Addendum 2
Solicitation 24-99842
Upper Lakeside Water Interconnect – Phase 1

ADDENDUM #2

Project Description City of Duluth
Upper Lakeside Zone Water Main Interconnect – Phase 1

PLAN & PROFILE
Sheet Title
Sheet Number
14

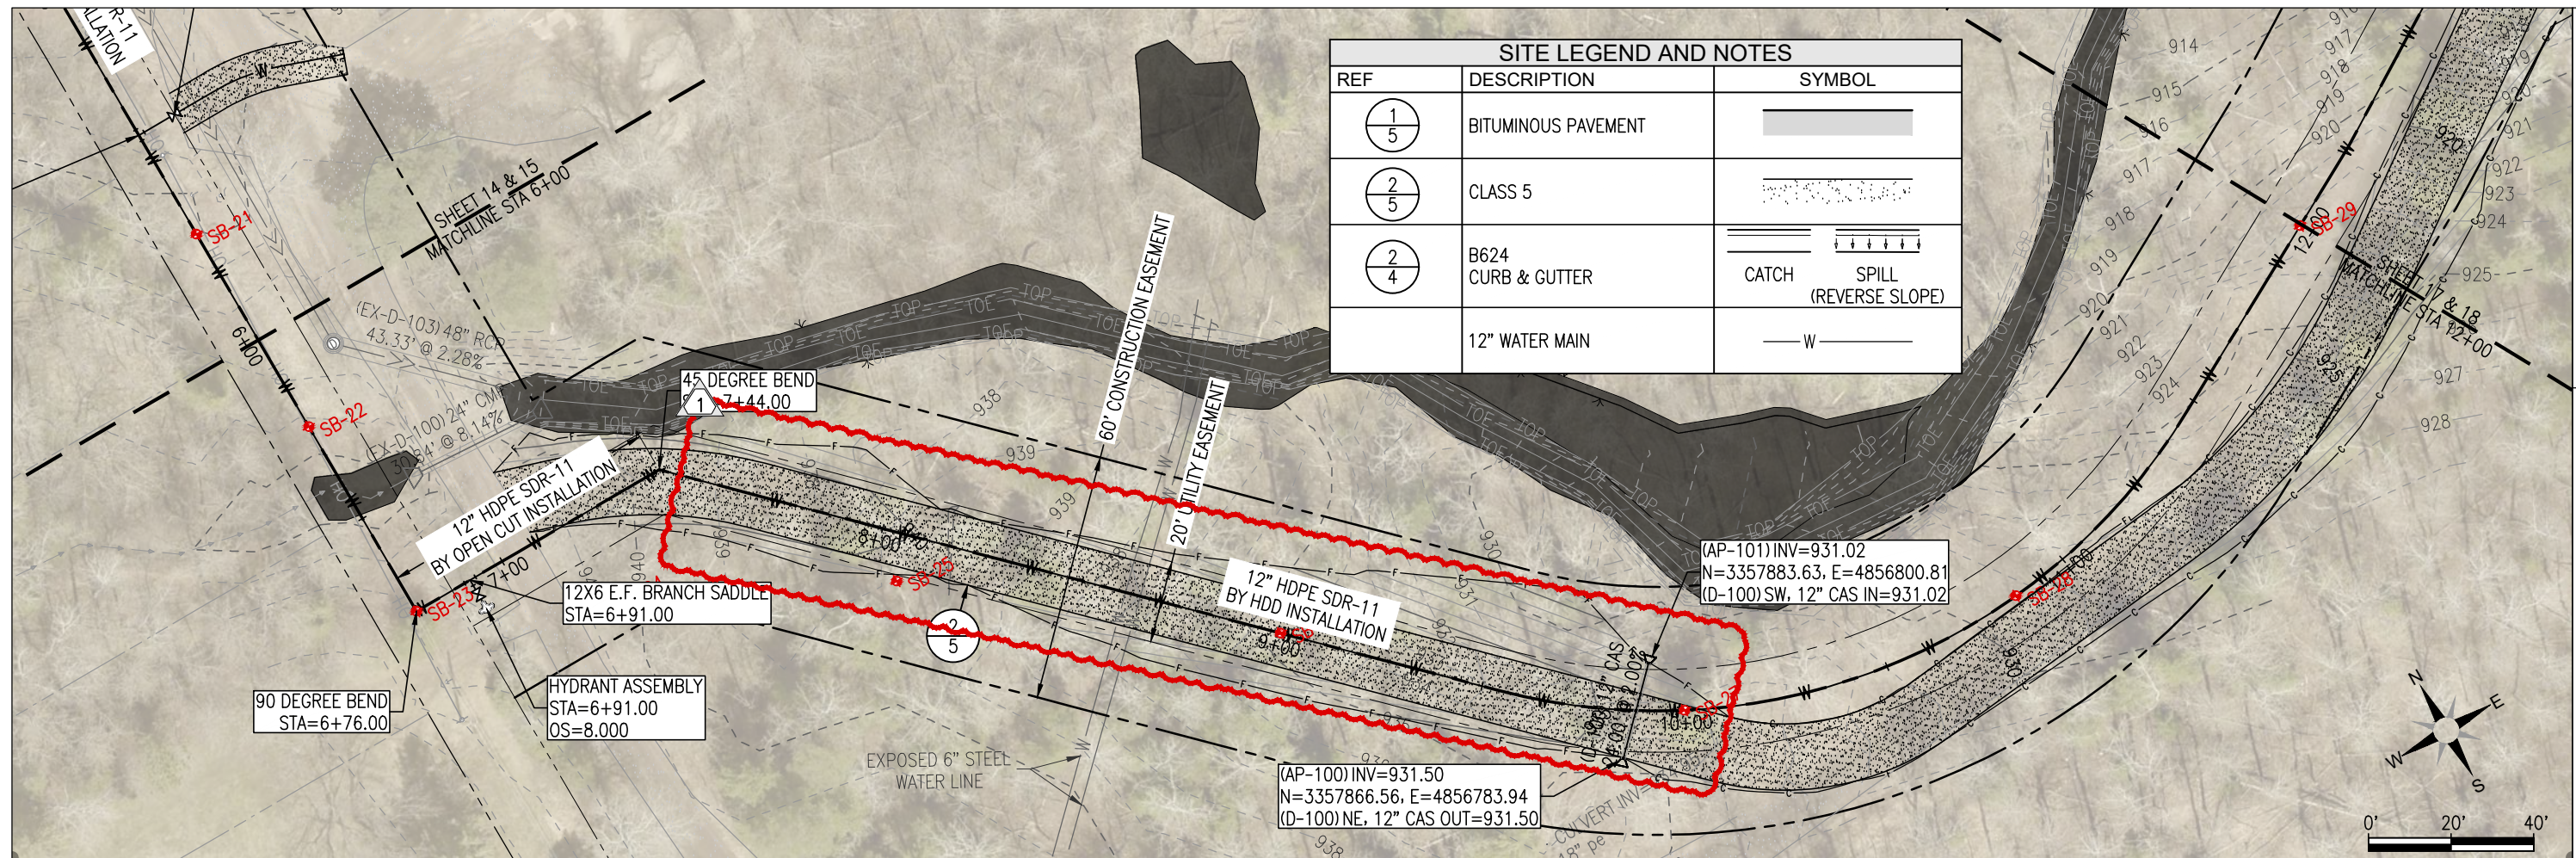
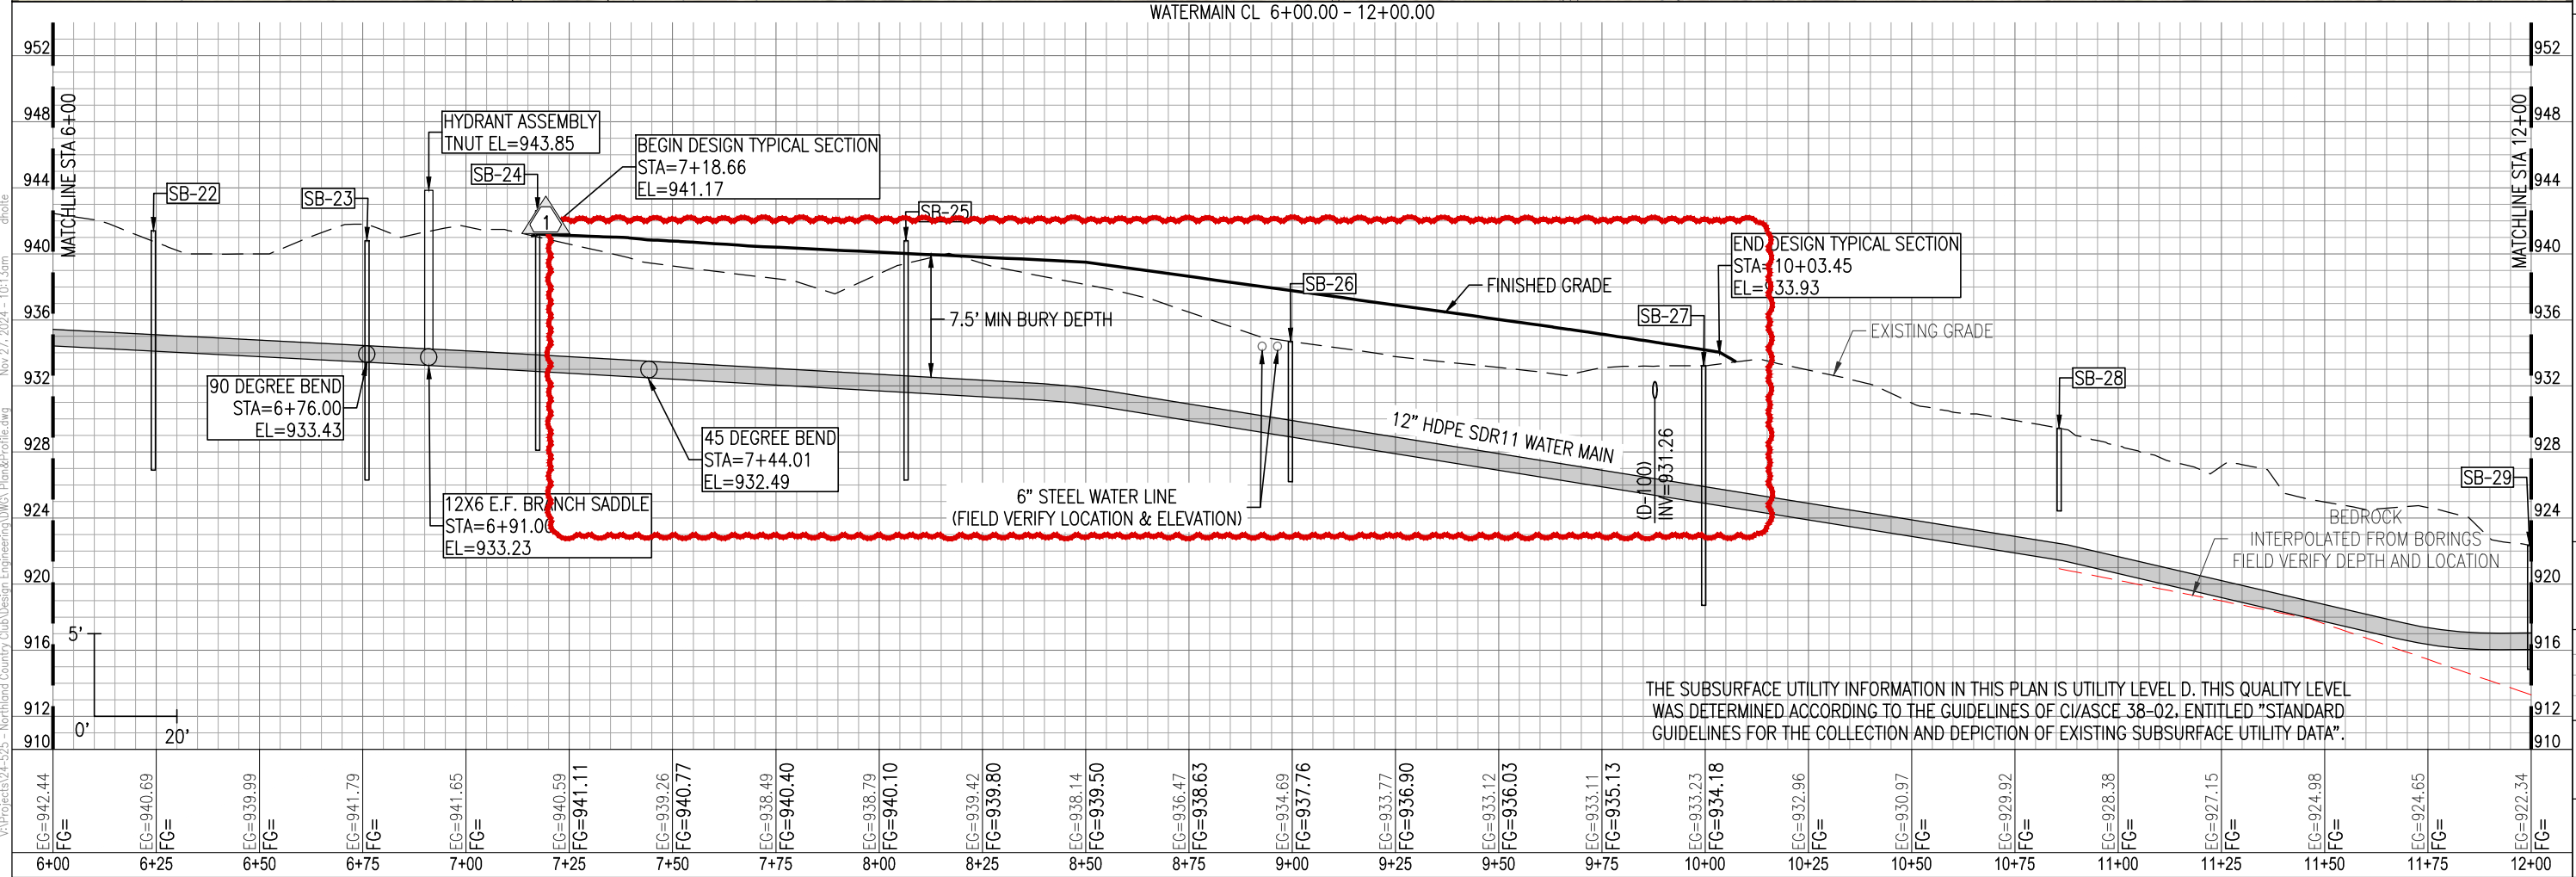
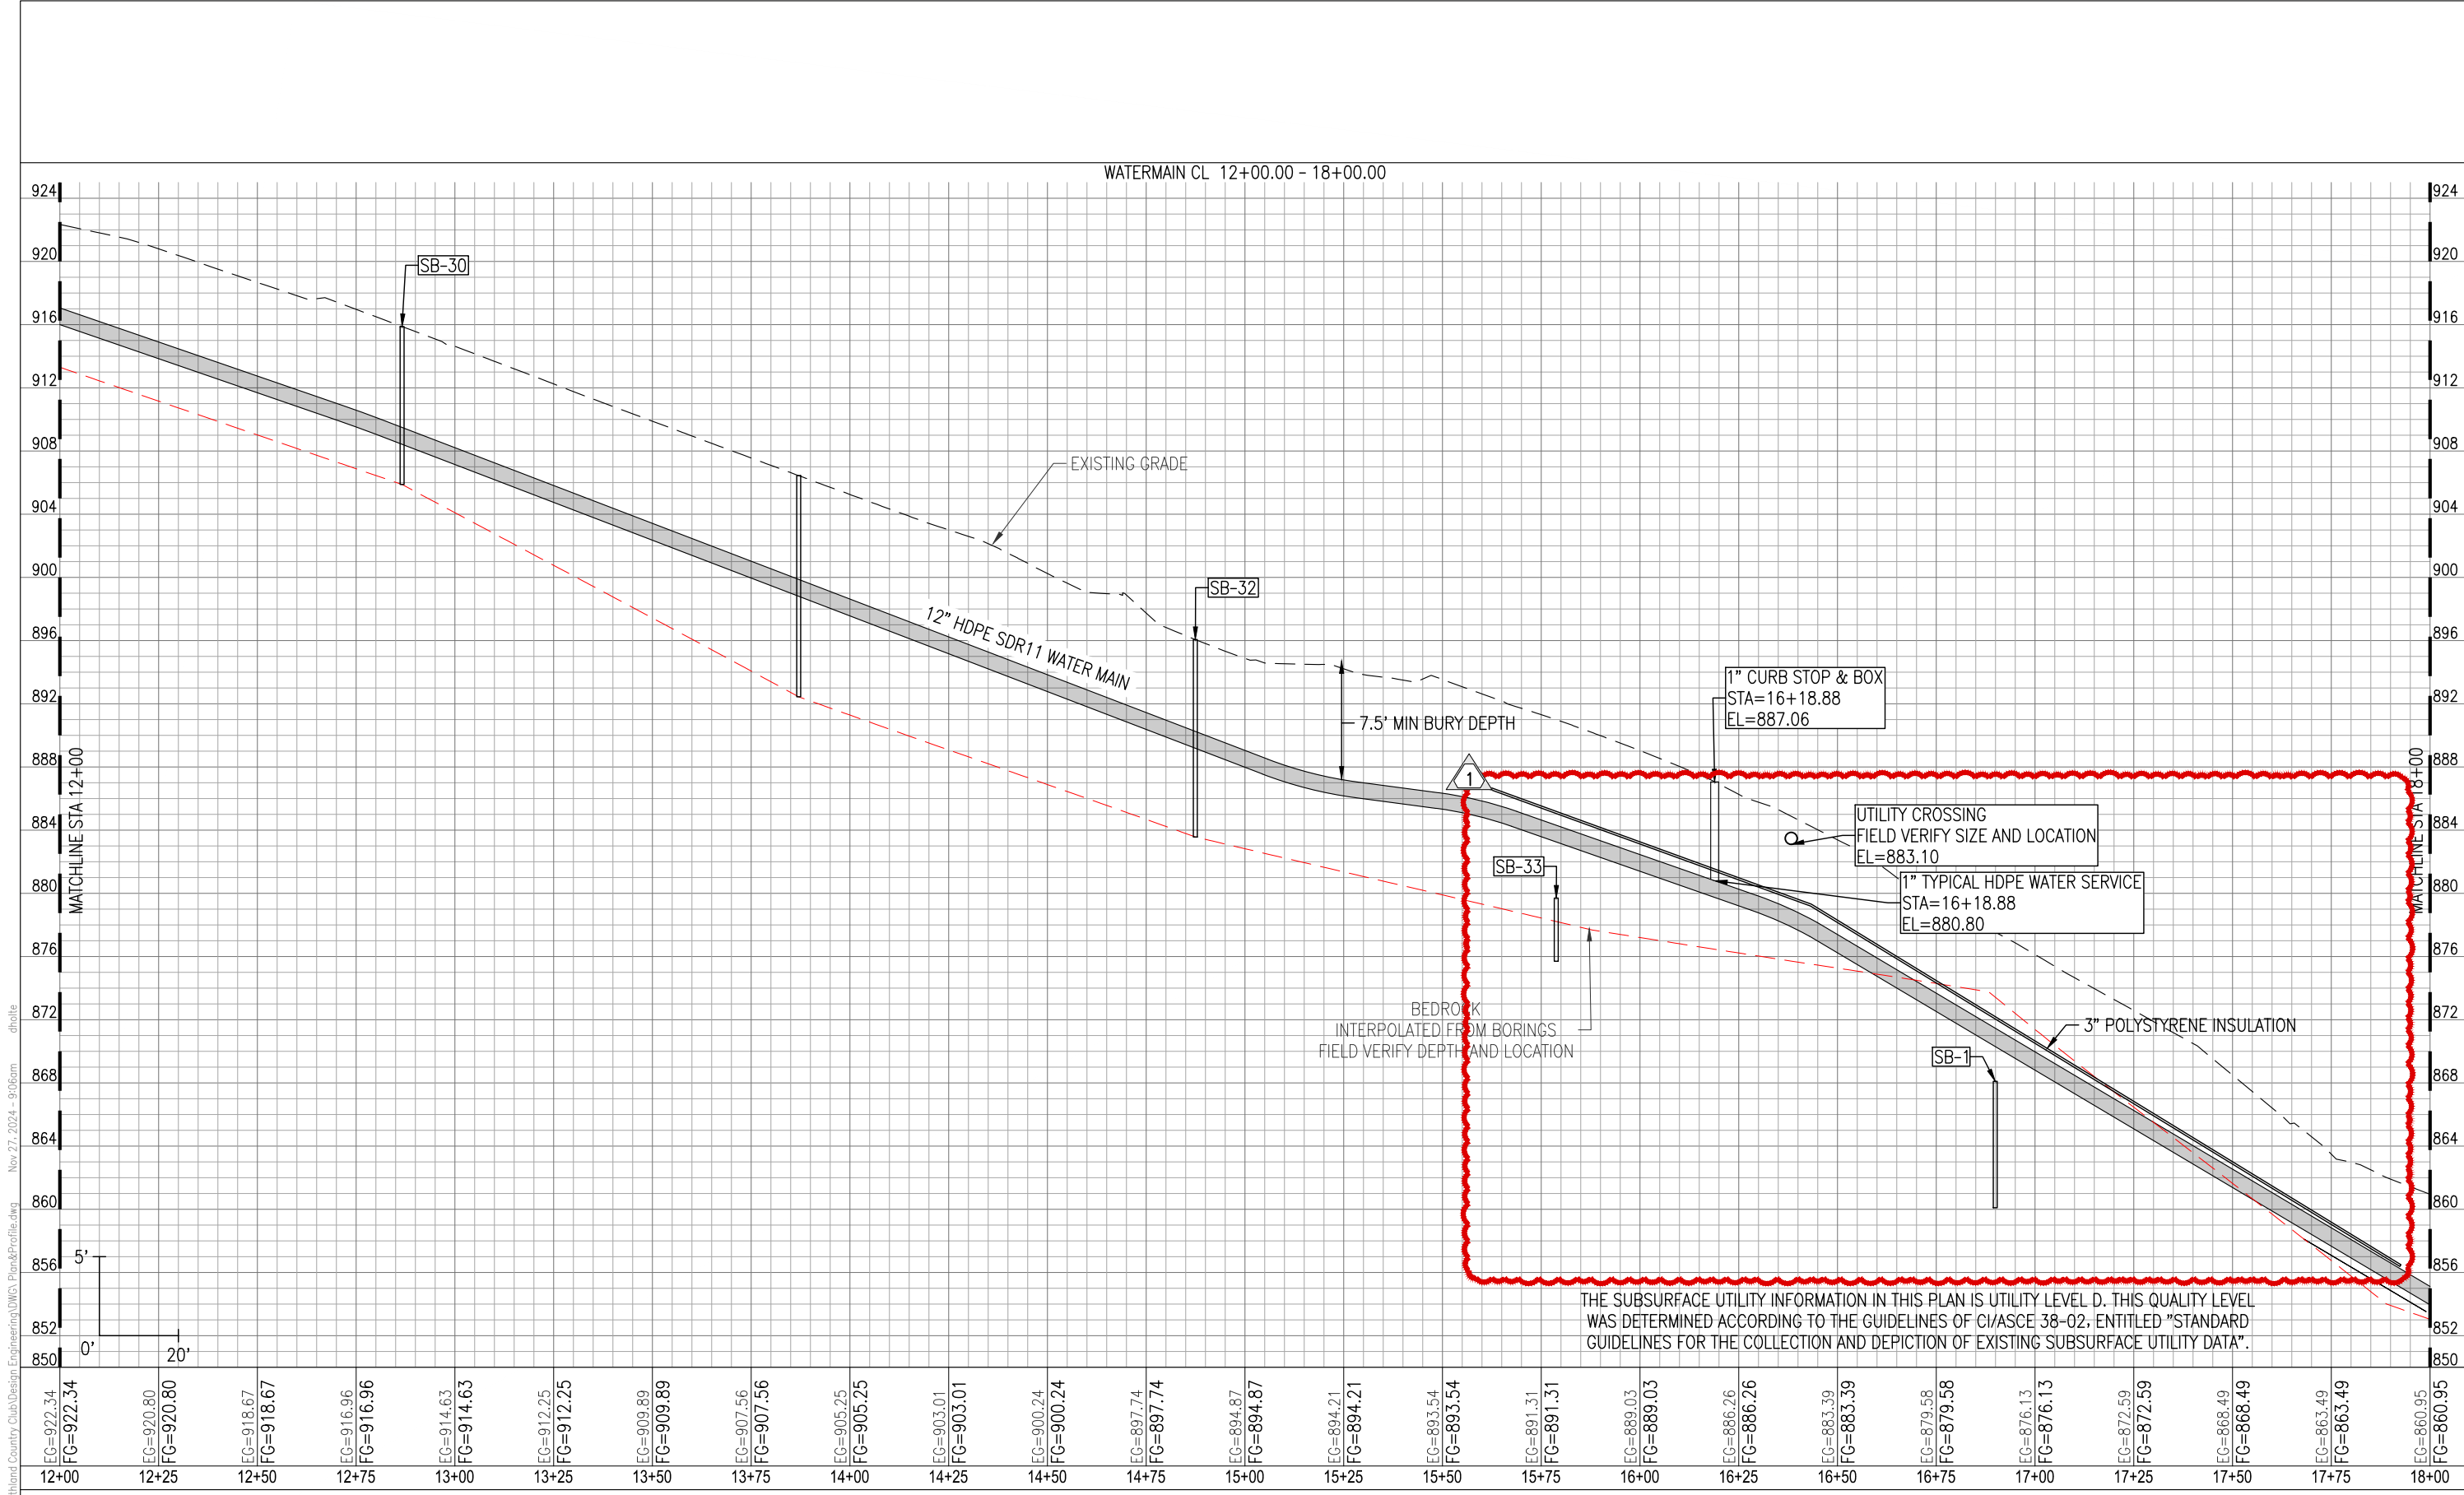
3. Sheet 10 EXISTING CONDITIONS AND REMOVALS: Existing pipe originally called out for removal will remain in place.
4. Sheet 14 PLAN AND PROFILE: Pipe EX-D-100 will not be replaced with new pipe.
